**Bid 643**  
**New HVAC Modernization Project for Rio Mesa High School**

**BID CLARIFICATION ADDENDUM #1**

Dated: December 30, 2020

- 3) Please refer to **Attachment B** for Architect's addendum 1

Job No. 2847.0200  
Date 10/23/2020  
**E-102A**

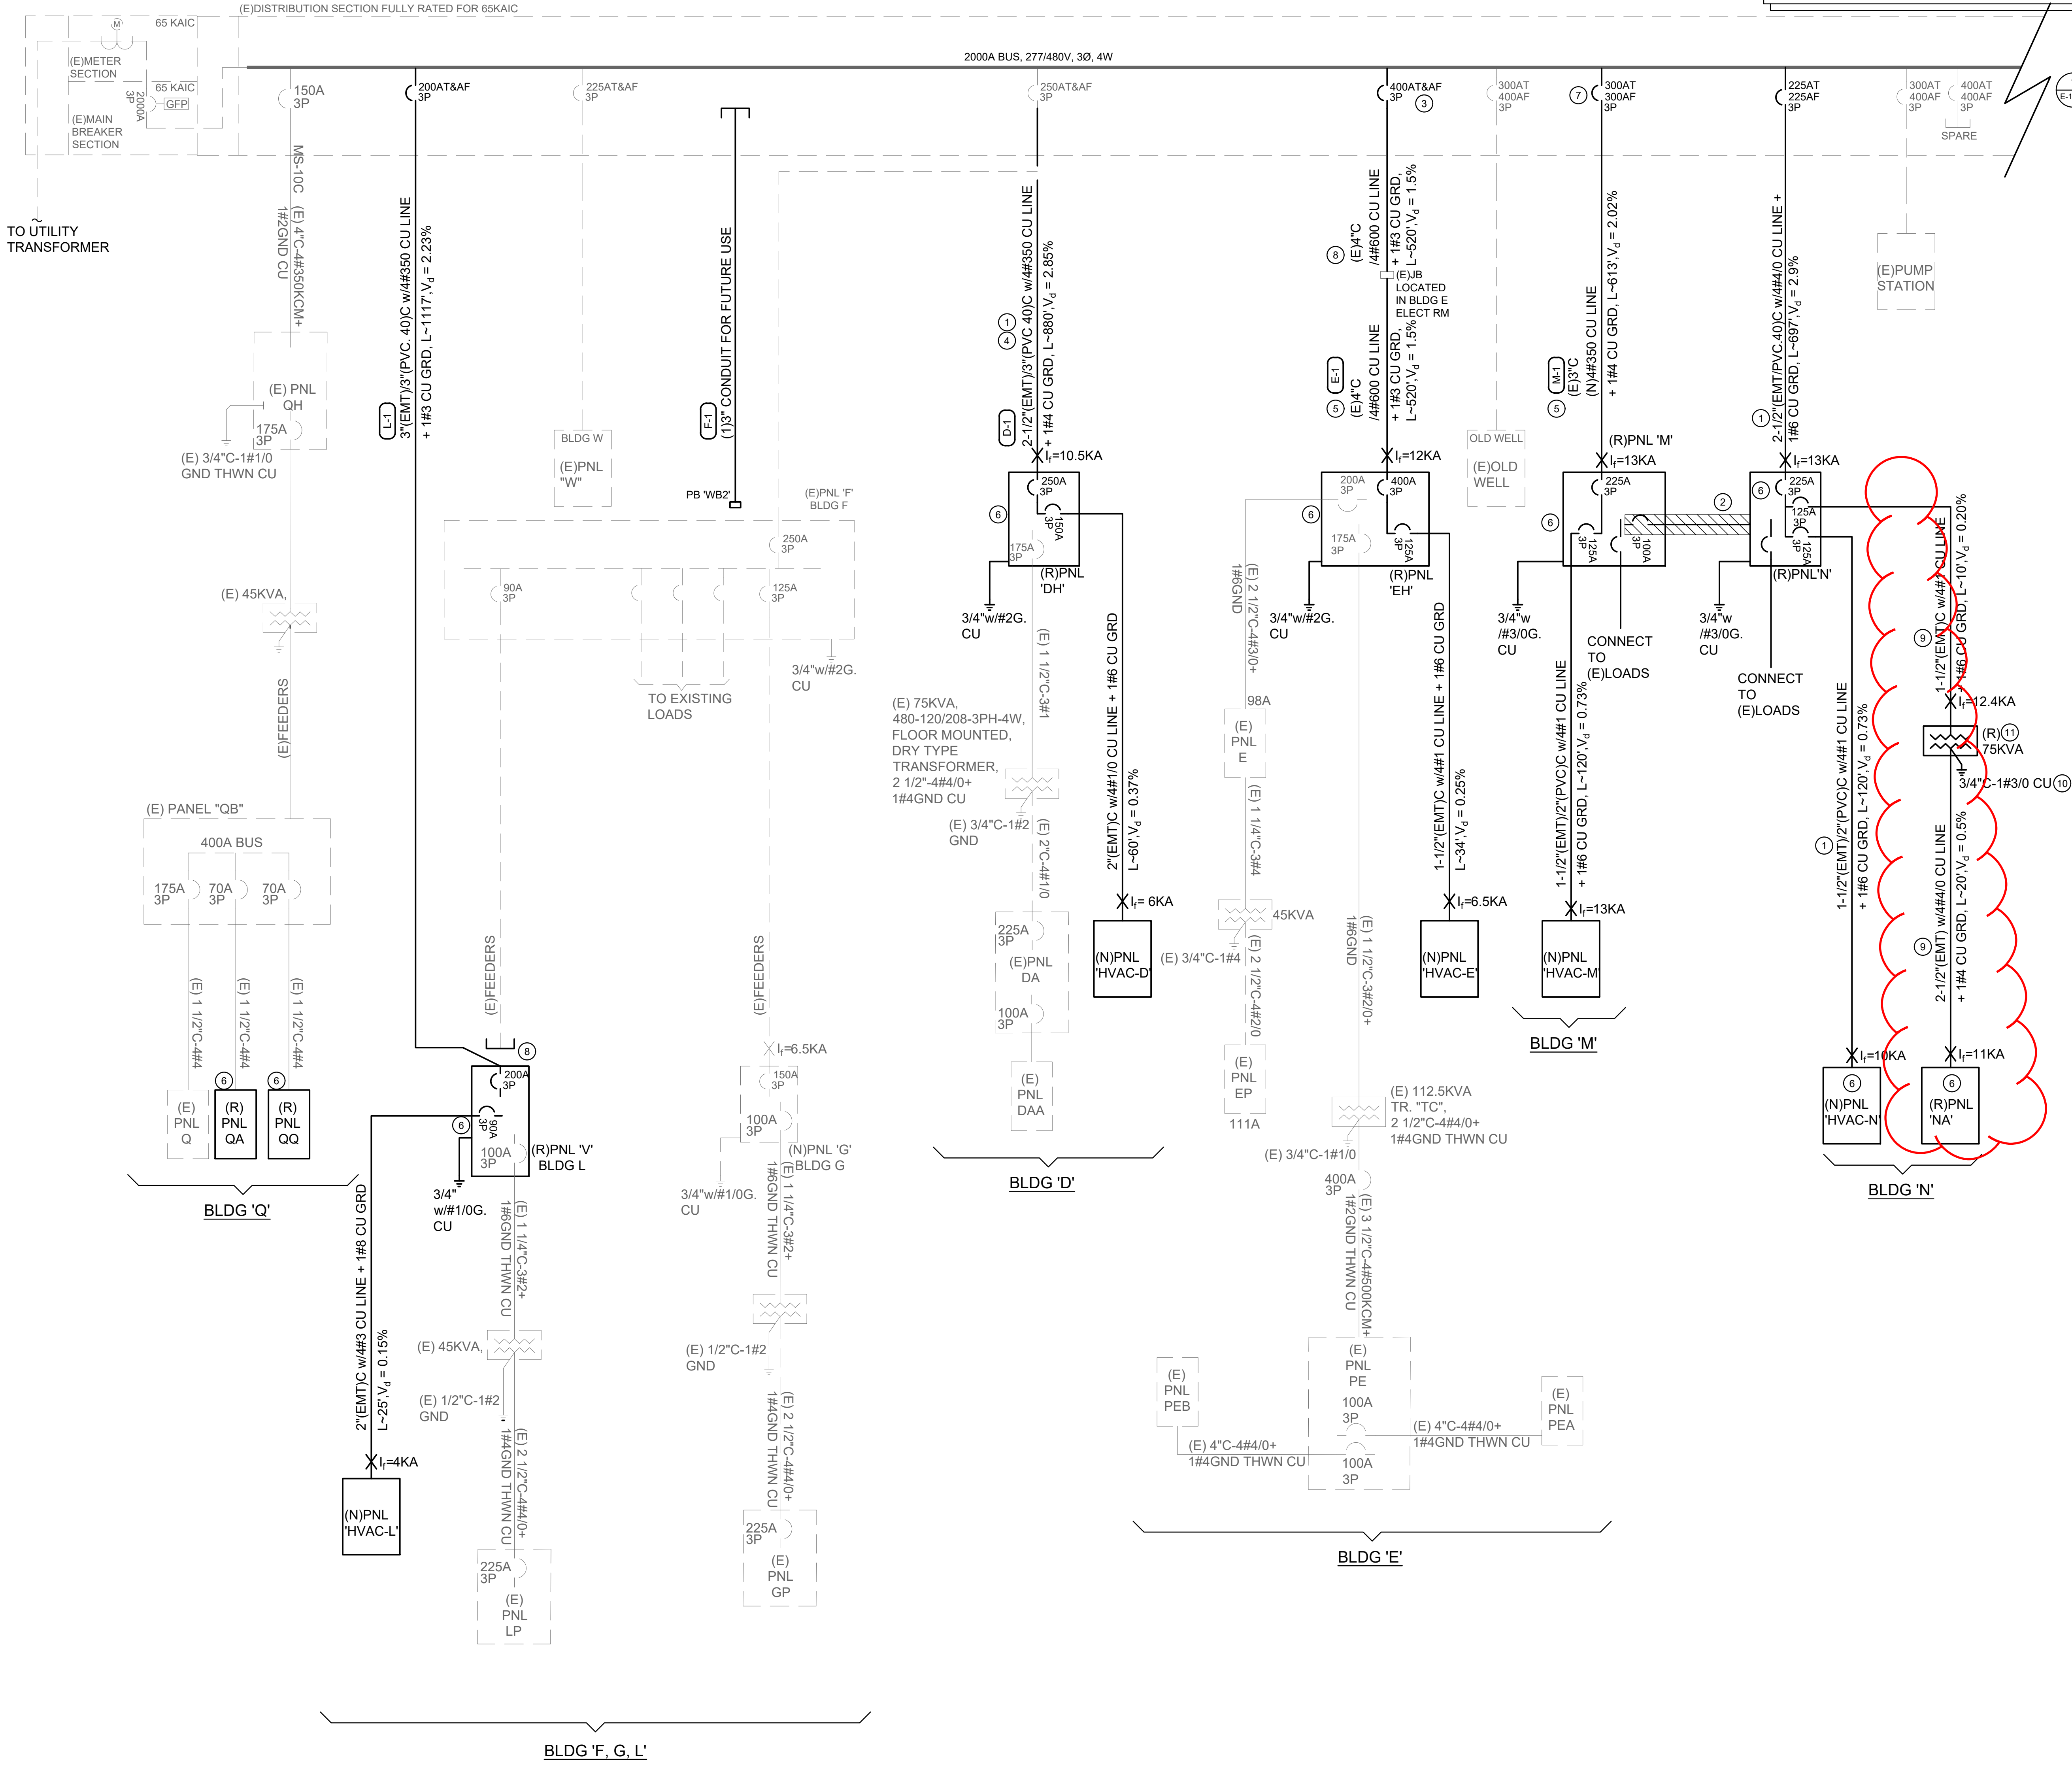
1. Please clarify if panel NA is existing to remain or is being replaced.
2. Please clarify scope for Panel HVAC-J. It is not shown on the single line or building plan but is shown as new in the panel schedules.
3. Please clarify scope for panel BP. Panel schedules and building plan show it as new, but the single line shows it as existing to remain.
4. Please clarify scope for panel C1. Panel schedules and building plan show it as new, but it is not shown on the single line.
5. Sheet EB201D is listed on sheet index and the pdf page 326 file has same name, however it appears to be a duplicate of EB-201. Can this missing page please be provided?

- 1 - PANEL NA IS BEING REPLACED, FLOOR PLANS ARE CALLING OUT AS REPLACED , I REVISED THE PANEL SCH AS WELL. SEE ATTACHED REVISED E-106D & E-106E. ALSO THE (E)45KVA XMER WILL NEED TO BE PLACED WITH (N)75KVA WITH ALL RELATED FEEDERS REVISED SHEET EN-201 AND E-102A, SEE ATTACHED
- 2 - WE ARE NOT USING HVAC-J ANYMORE, REVISED THE PNL SCH TO REMOVE HVAC-J, SEE ATTACHED REVISED E-106C
- 3 - I BELIEVE YOU MEAN 'PB' AND NOT 'BP' WE DONT HAVE 'BP' SHOWN ON FLOOR PLANS OR PNL SCH, WE ARE REPLACING 'PB', SEE REVISED SINGLE LINE DIAGRAM E102B WITH PB BEING CALLED OUT AS REPLACED
- 4 SHOWN PANEL C1 ON SINGLE LINE, ALSO CHANGED AIC AND SCCR TO 18KA, ALSO ADDED A NOTE IN (E)PC PANEL SCH SEE REVISED E102B, E106A
- 5 - ATTACHED IS EB201D

Job No:  
2847.0200  
Date:  
10/23/2020  
**MB-201**

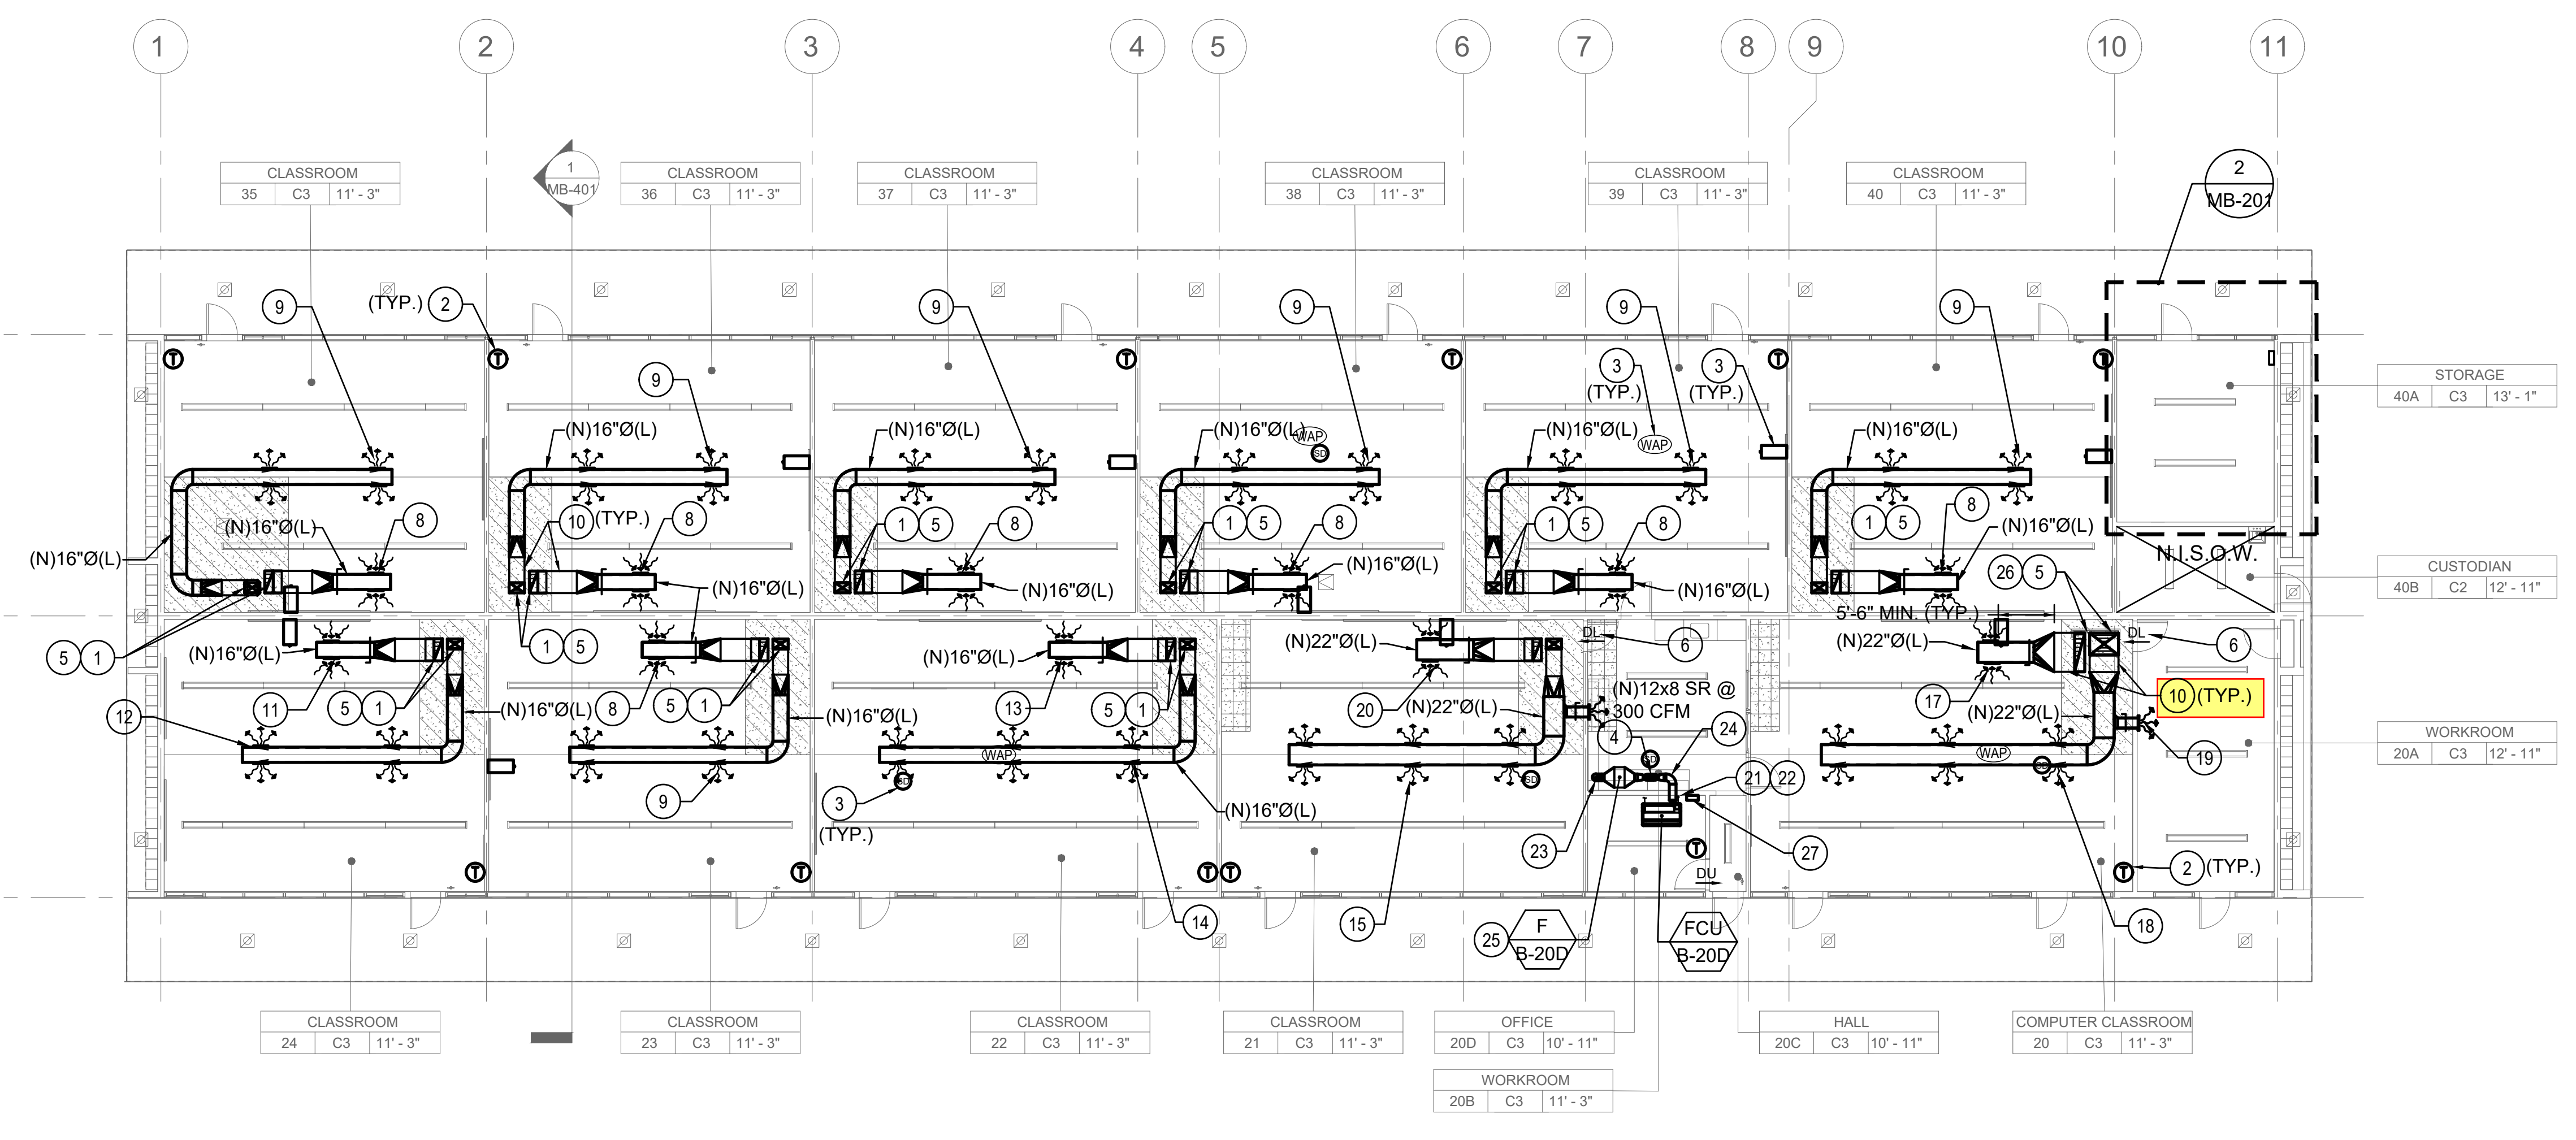
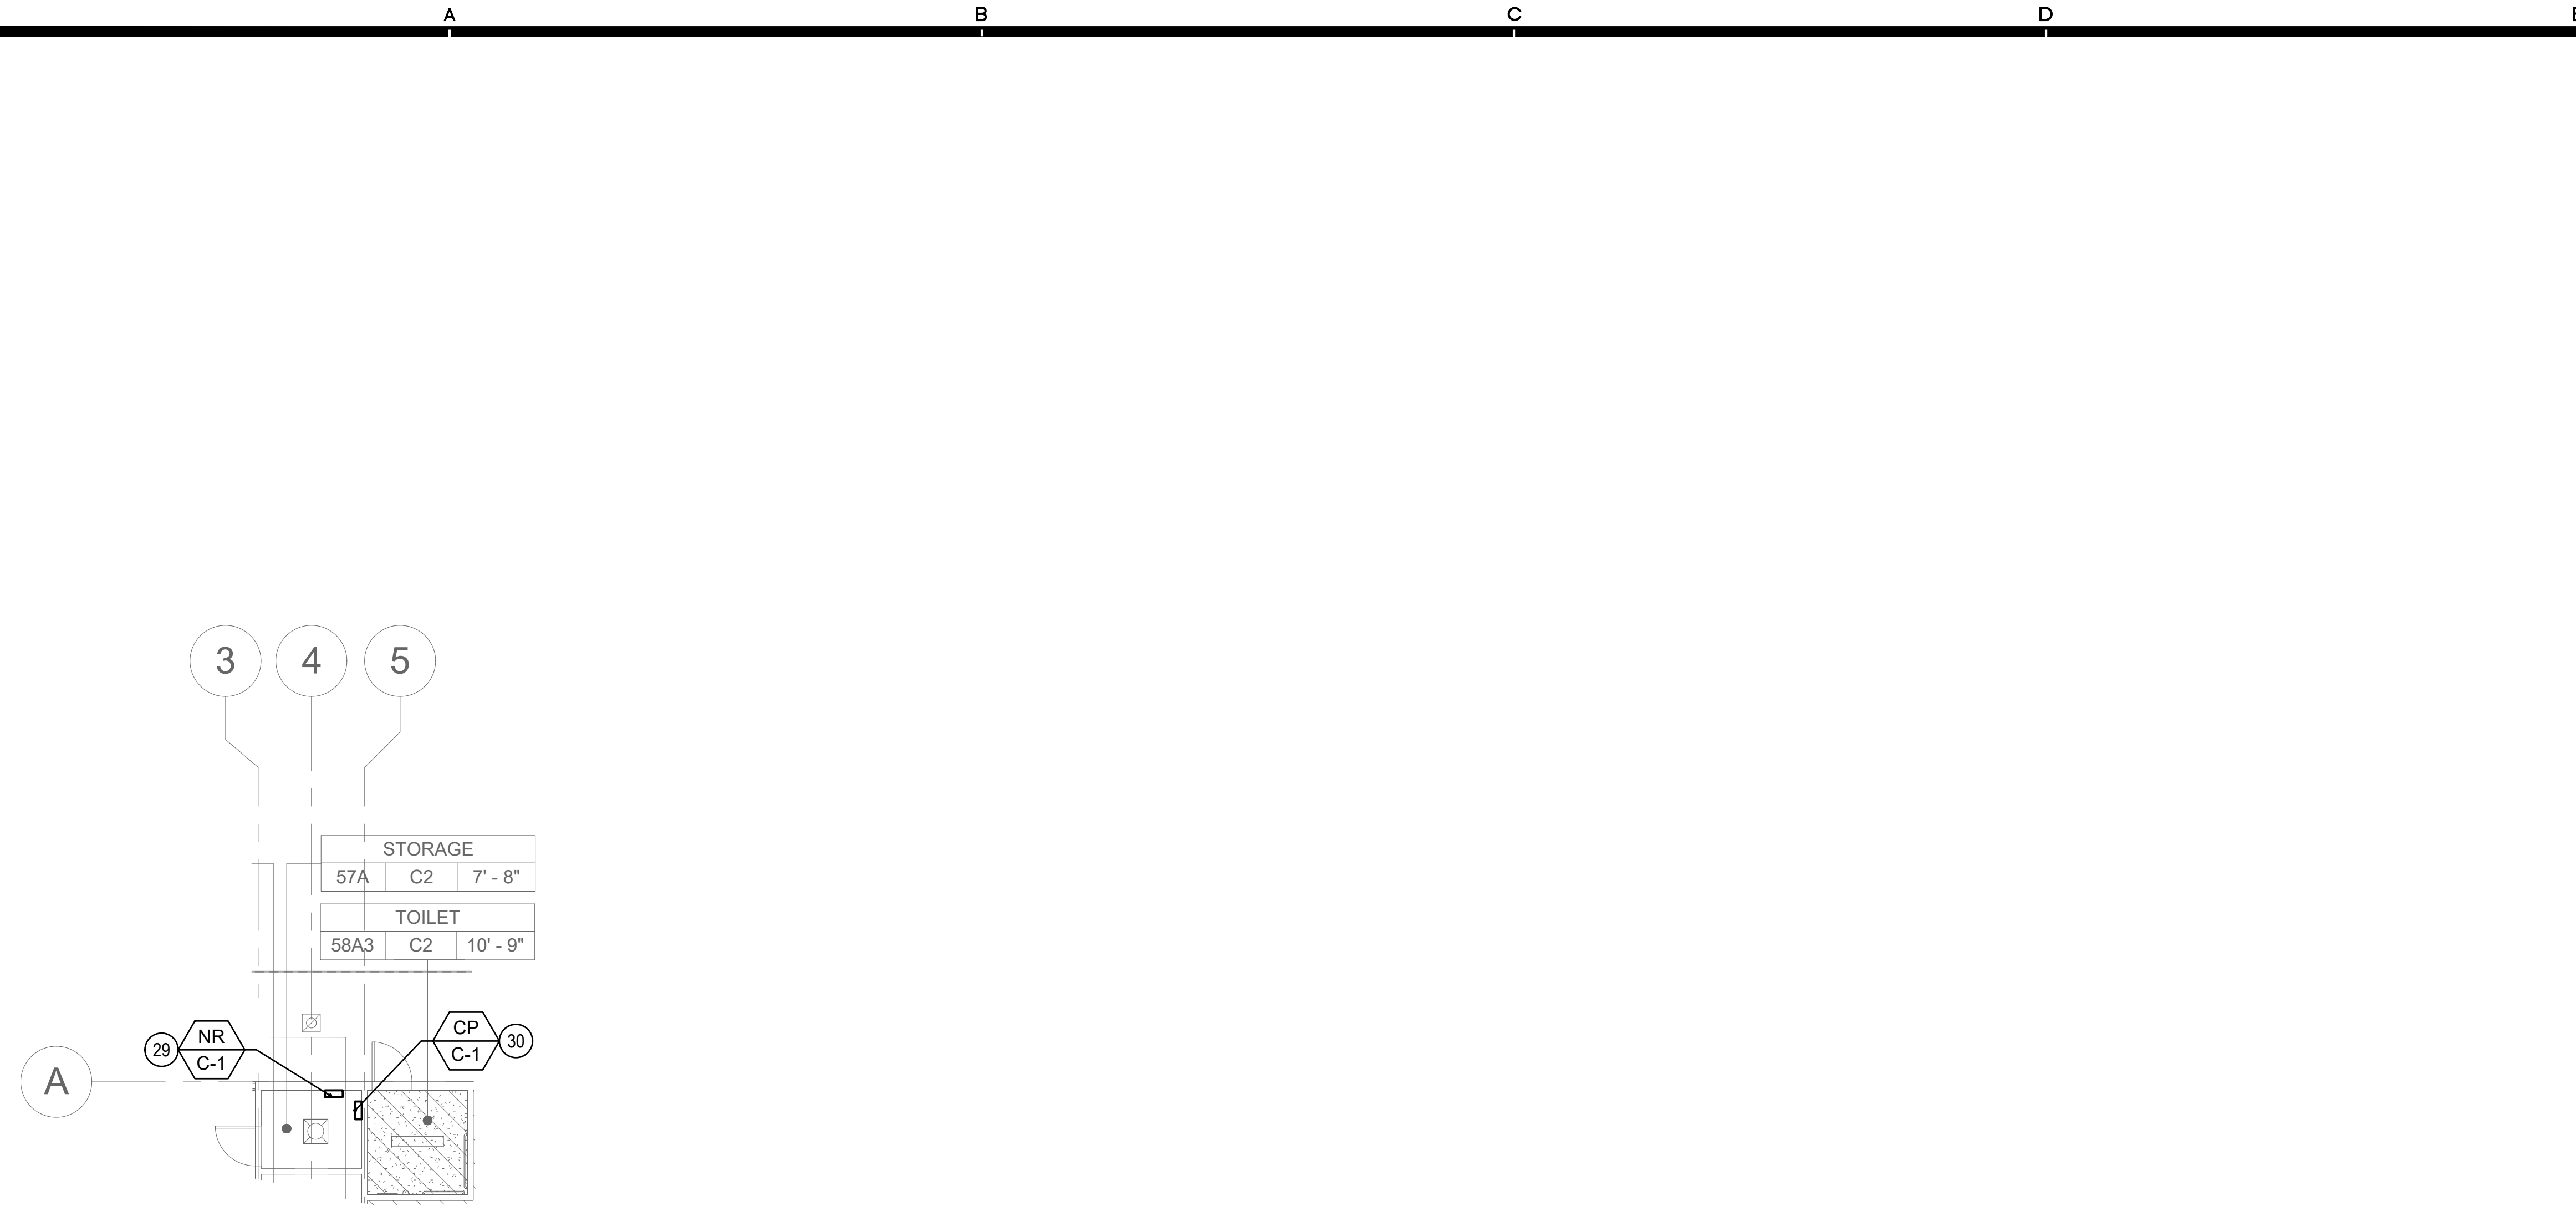
- 1) Are duct silencers required for the return ducts?
- 2) Can the engineer provide a schedule of the required duct silencers with basis of design model numbers?

- 1) Yes.
- 2) See updated sheet M-007 with duct silencer schedule. See updated specification section 23 33 01 without strikethroughs. Patrick Fitzsimmons - Budlong & Associates - 12/18/2020
